SUBJECT: ISSUANCE OF AMENDMENT NO. 188 TO FACILITY OPERATING LICENSE NO. DPR-51 - ARKANSAS NUCLEAR ONE, UNIT NO. 1 (TAC NO. M97529)

AMENDMENT TO FACILITY OPERATING LICENSE

Amendment No. 188
License No. DPR-51

SAFETY EVALUATION BY THE OFFICE OF NUCLEAR REACTOR REGULATION

FIGURE 3.1.2-1
RCS INSERVICE HYDROSTATIC TEST H/U & C/D LIMITS TO 31 EFPY

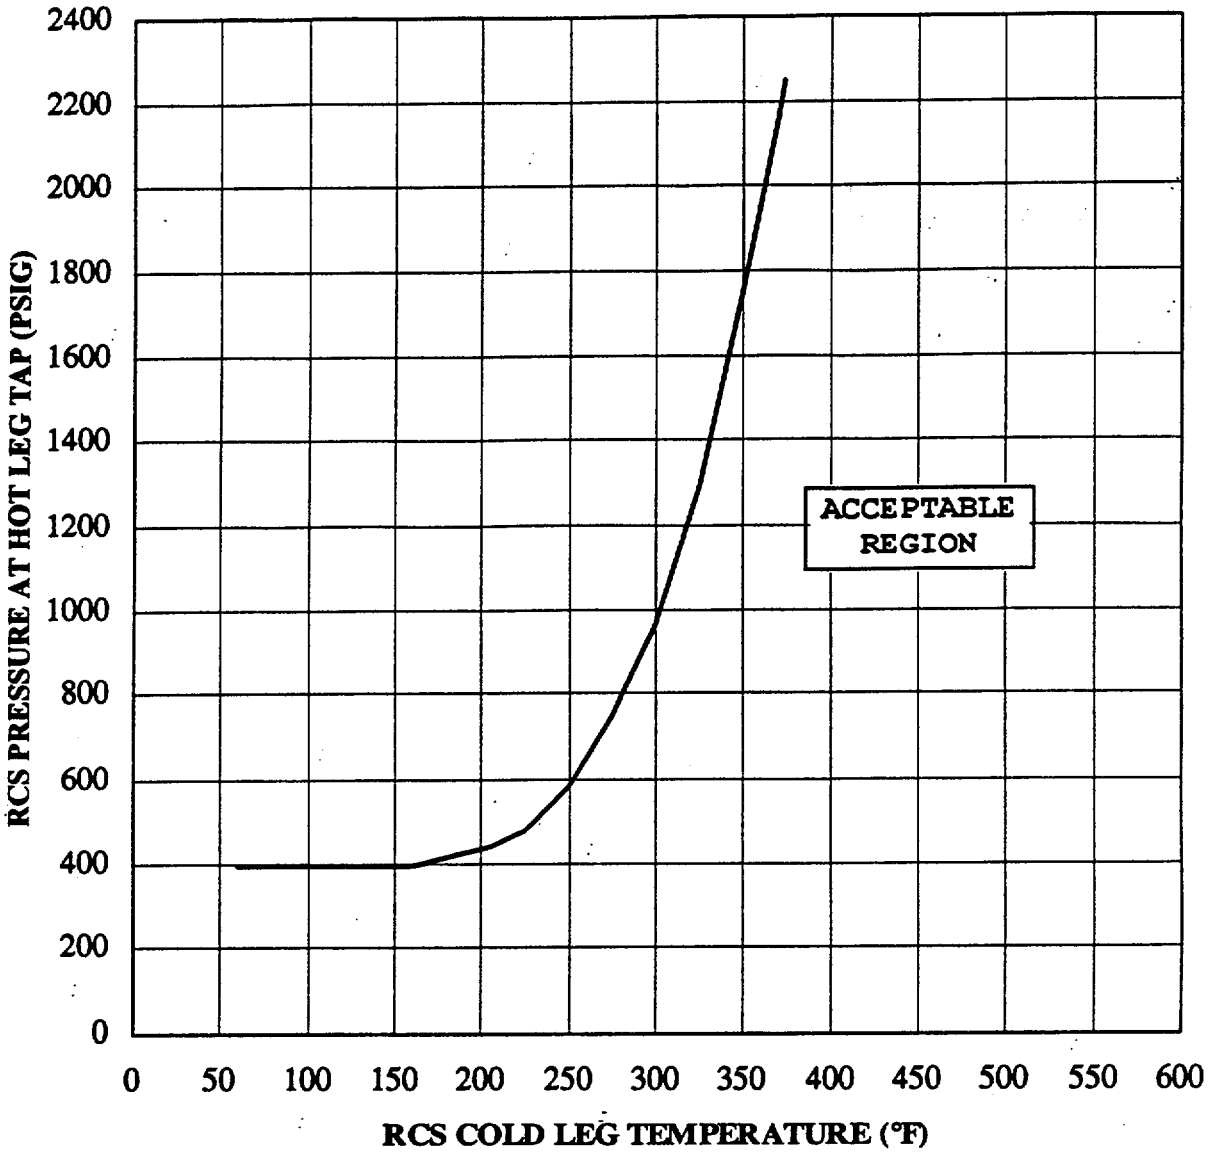
Figures 3.1.2-1, 3.1.2-2, and 3.1.2-3 present the pressure-temperature limit curves for hydrostatic test, normal heatup, and normal cooldown respectively. The limit curves are applicable through the thirty first effective full power year of operation. The service period was reduced by one effective full power year from that assumed in FTI Document 77-1258569-01 to be conservative with respect to independent calculations performed by the NRC staff. The pressure limit is also adjusted for the pressure differential between the point of system pressure measurement and the limiting component for all allowed operating reactor coolant pump combinations.

The pressure-temperature limit lines shown on Figure 3.1.2-2 for reactor criticality and on Figure 3.1.2-1 for hydrostatic testing have been provided to assure compliance with the minimum temperature requirements of Appendix G to 10CFR50 for reactor criticality and for inservice hydrostatic testing.

Therefore, the staff has determined that by summing the initial RT_{NDT} of -5°F, the margin value of 68.5°F and the ΔRT_{NDT} of 150°F, the ART should be 213.5°F. Substituting the ART of 213.5°F for ANO-1 into equations in SRP 5.3.2, the staff determined that the proposed P-T limits for heatup, cooldown, hydrotest, and criticality meet the beltline material requirements in Appendix G of 10 CFR Part 50 for 31 EFPY.

The staff concludes that the proposed P-T limits for the reactor coolant system for heatup, cooldown, leak test, and criticality satisfy the requirements in Appendix G to Section XI of the ASME Code and Appendix G of 10 CFR Part 50 for 31 EFPY. The proposed P-T limits also satisfy GL 88-11 because the method in RG 1.99, Rev. 2 was used to calculate the ART. Hence, the proposed P-T limits may be incorporated into the ANO-1 TSs.
